**COMMENT RESPONSE MATRIX FOR COMMENTS ON SAVANNAH RIVER REMEDIATION (SRR)  
INDUSTRIAL WASTEWATER CLOSURE MODULE FOR F-AREA DIVERSION BOXES 5 AND 6 F-AREA TANK FARM,  
SAVANNAH RIVER SITE, SRR-CWDA-2020-00011, REVISION 0A.**

<b>UNITED STATES DEPARTMENT OF ENERGY SAVANNAH RIVER SITE</b>		SRR-CWDA-2021-00013, Revision 0	February 22, 2021
<b>Document Reviewed:</b> SRR-CWDA-2020-00011, <i>Industrial Wastewater Closure Module for F-Area Diversion Boxes 5 and 6 F-Area Tank Farm, Savannah River Site</i>		<b>Rev.:</b> 0A	<b>Doc. Date:</b> December 15, 2020
<b>Commenter(s):</b> South Carolina Department of Health and Environmental Control (SCDHEC), U.S. Environmental Protection Agency (EPA), U.S. Department of Energy (DOE)		<b>Contact:</b> Joseph Pavletich	
<b>No.</b>	<b>Comment</b>	<b>Comment Response</b>	
<b>SCDHEC and EPA comments received via email January 22, 2021; “Industrial Wastewater Closure Module for F-Area Diversion Boxes 5 and 6, F-Area Tank Farm, Savannah River Site, SRR-CWDA-2020-00011 Draft Revision 0A received via email on 12/15/2020.”</b>			
<b>General Comments</b>			
None. Editorial comments regarding spelling, grammar and punctuation have been verbally conveyed to Mr.

**Attachment A:**  
**Revised FDB-5 and 6 Closure Module Figure 5.3-1**

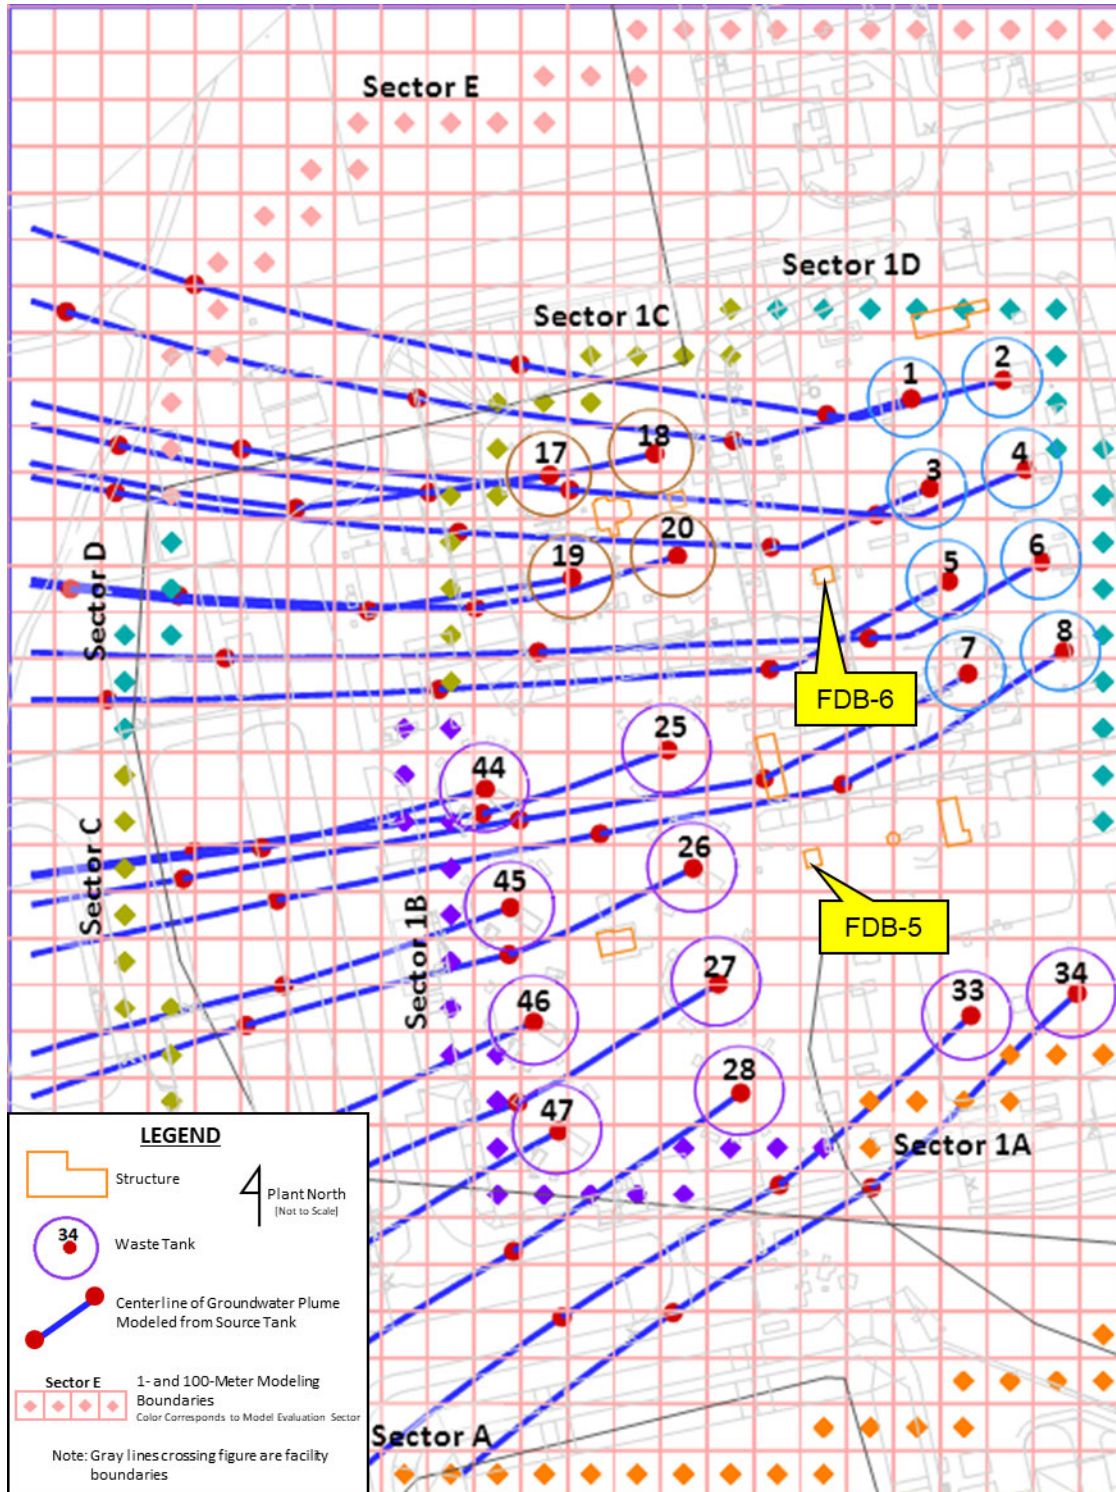
3	Figure 5.3-1 FTF 1-meter and 100-meter PORFLOW Model Evaluation Sectors of the Closure Module does not include a figure legend to define all the elements (e.g., symbols, lines, colors) depicted in the figure. It is noted the same figure is presented as Figure 6.3-1 in the FDB-5 and FDB-6 Special Analysis for the Performance Assessment for the F-Tank Farm at the Savannah River Site. Figure 6.3-1 also does not include a figure legend but does include a note at the bottom of the figure that states “The individual sectors are indicated by unique diamond colors.” <i>Please revise Figure 5.3-1 of the Closure Module to include a legend defining all the elements (e.g., symbols, lines, colors) depicted in the figure.</i>	<i>A legend will be added to Closure Module Figure 5.3-1 as shown in Attachment A of this comment response matrix.</i>
